Project	IEEE 802.16 Broadband Wireless Access Working Group < http://ieee802.org/16 >
Title	Correct Figure for TEK management in BS and MS
Date Submitted	2005-07-19
	Sangwoo Doe, Sungsoo Oh, SungHo Yoo POSDATA Co. LTD
	doeing@posdata.co.kr
Re:	Response to Sponsor Ballot on IEEE802.16e/D8 document
Abstract	This contribution corrects the figure for TEK management in BS and MS.
Purpose	To incorporate the figure changes proposed in this contribution into the 802.16e/D9 draft.
Notice	This document has been prepared to assist IEEE 802.16. It is offered as a basis for discussion and is not binding on the contributing individual(s) or organization(s). The material in this document is subject to change in form and content after further study. The contributor(s) reserve(s) the right to add, amend or withdraw material contained herein.
Release	The contributor grants a free, irrevocable license to the IEEE to incorporate material contained in this contribution, and any modifications thereof, in the creation of an IEEE Standards publication; to copyright in the IEEE's name any IEEE Standards publication even though it may include portions of this contribution; and at the IEEE's sole discretion

Figure 134—TEK management in BS and SS

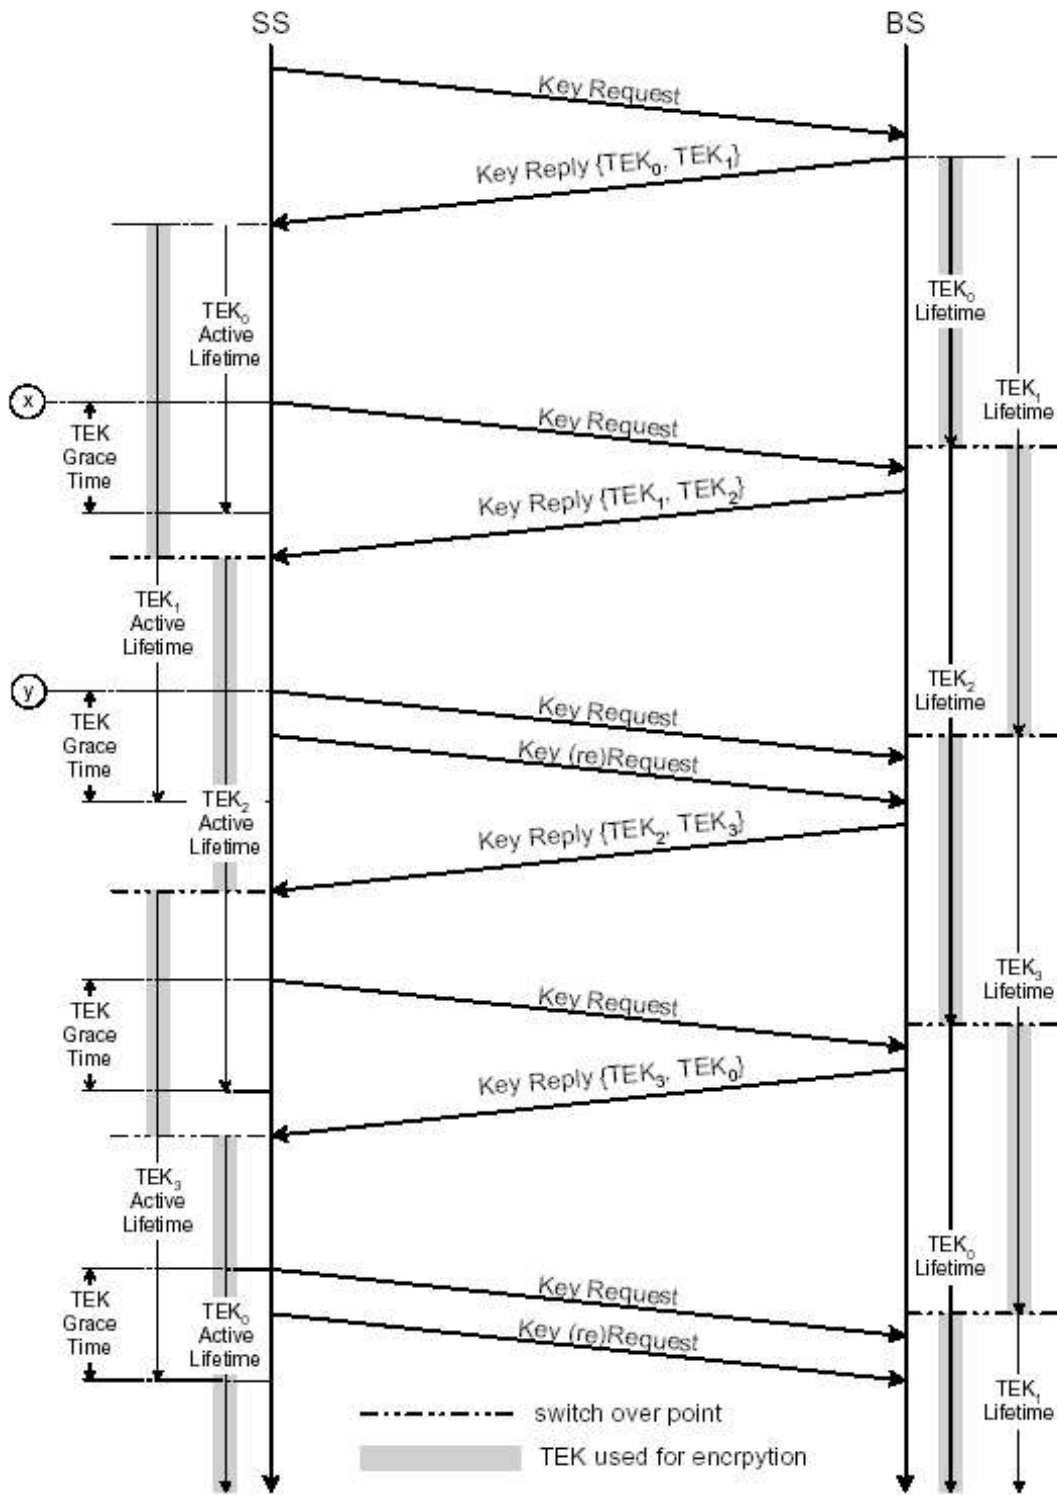
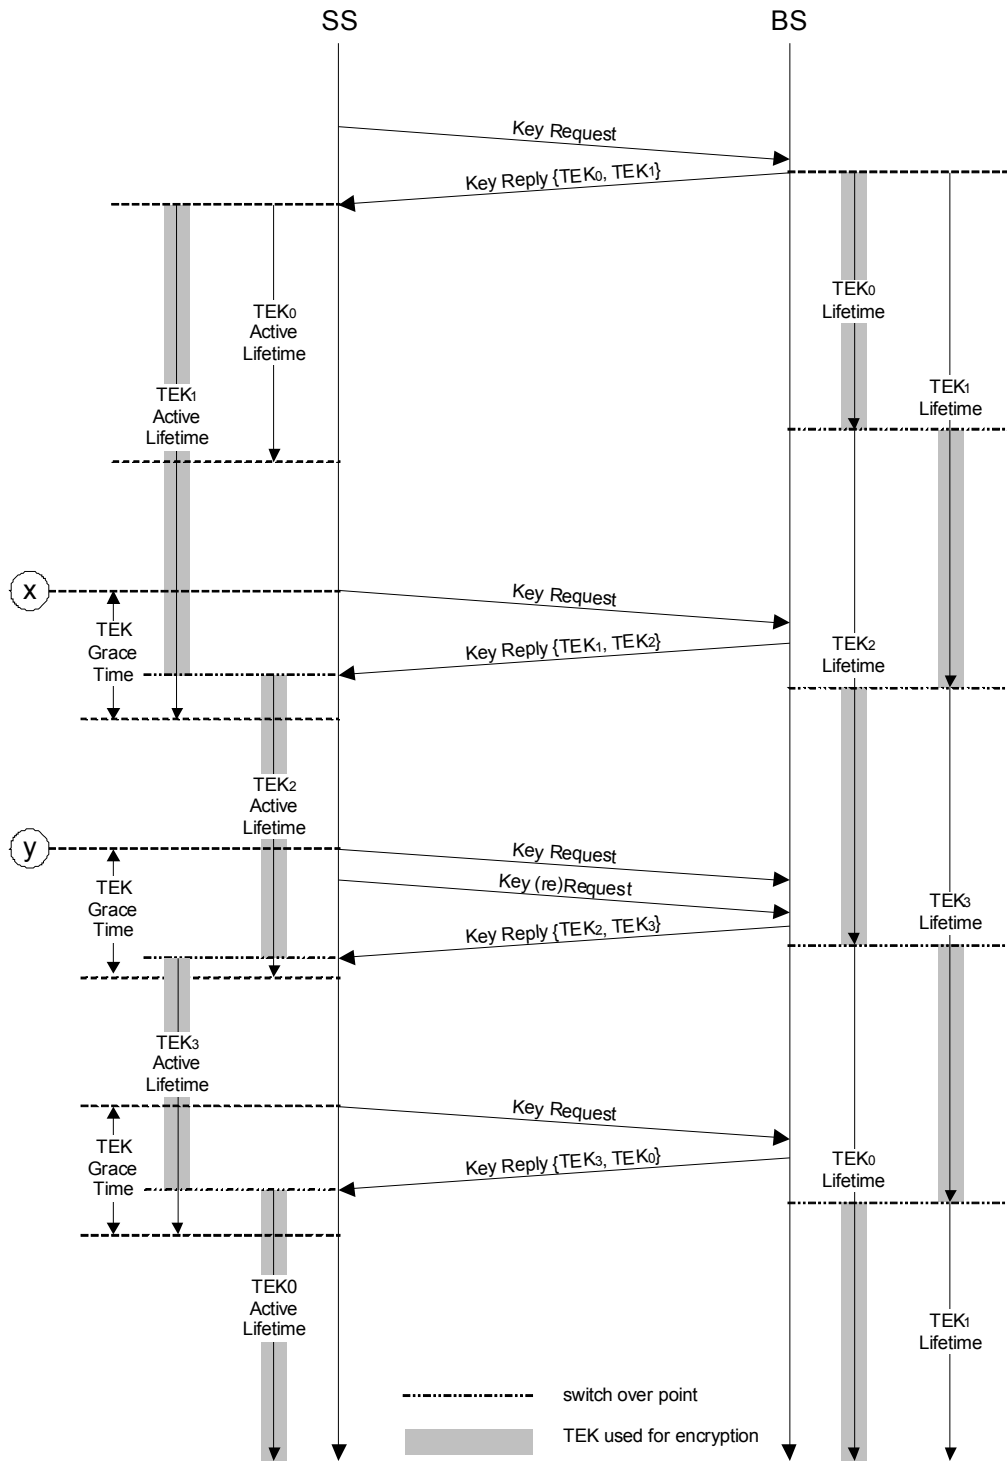
However, Figure 134 of 802.16-2004 is incorrect, **as the current figure shows that an SS sends Key Request message to the BS when TEK0 Refresh Timer is fired [see points (x)]. Also, it shows that the BS receives Key Request message after TEK0 Lifetime expires. Therefore, SS and BS cannot synchronize TEKs. Figure 134 of 802.16-2004 needs correction so it can comply with the texts in IEEE 802.16-2004.**

We propose a correct figure in the below. In the proposed figure, an SS sends Key Request message to the BS when TEK1 Refresh Timer is fired [see points (x)] and the BS receive Key Request message before TEK1 Lifetime expires.

[Replace Figure 134 of 802.16-2004 with a new figure:]
